**SERVICE
BULLETIN**

SERVICE BULLETIN no. 5/07/2007

The U-068 T Cutaway Release Adjustment

Diagram and photographic documentation of the adjustment on the U – 068 T cutaway release .

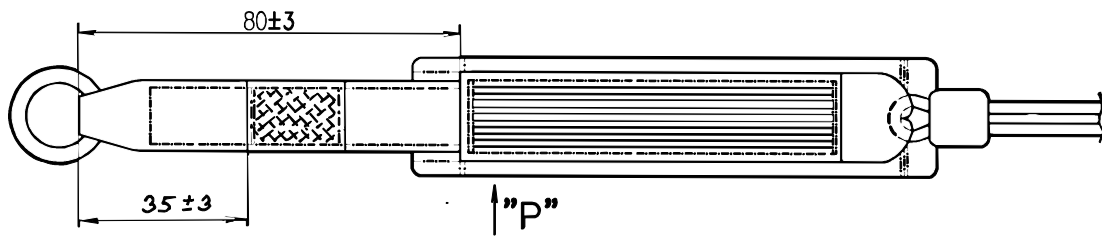
- 1. APPLIES TO:** The U – 068 T cutaway release, a part of the MarS – T Tandem parachute manufactured by MarS a.s. Jevíčko.
- 2. REASON:** Information for the users of the MarS – T tandem parachute. During a jump the U – 068 T cutaway release webbing was seized by the pilot by hand together with the secondary brake parachute release, and as he pulled out the secondary release, also the main canopy was cut away.

2. As a technical, safety and reliability product improvement and a preventive measure against an unwanted pull out of the cutaway release jointly with the secondary release, the manufacturer recommends to perform an adjustment of the U – 068 T cutaway release – see the diagram and photographic documentation in the Appendix No. 1.
The adjustments consists of an additional sewing of a Velcro strap - grain size 20 x 15 mm - onto the webbing located on the place where the cutaway release and the secondary release are joined, in the distance of 35 ± 3 mm from the webbing edge with a ring,

3. After the cutaway release and the secondary release are attached on the tandem parachute, the webbing on the U – 068 T cutaway release is inserted under the cover on the shoulder pad and a Velcro strap secures it against a possible slide out. This measure prevents the creation of a loop on the webbing and eliminates a possible joint pull out of the secondary and cutaway releases.
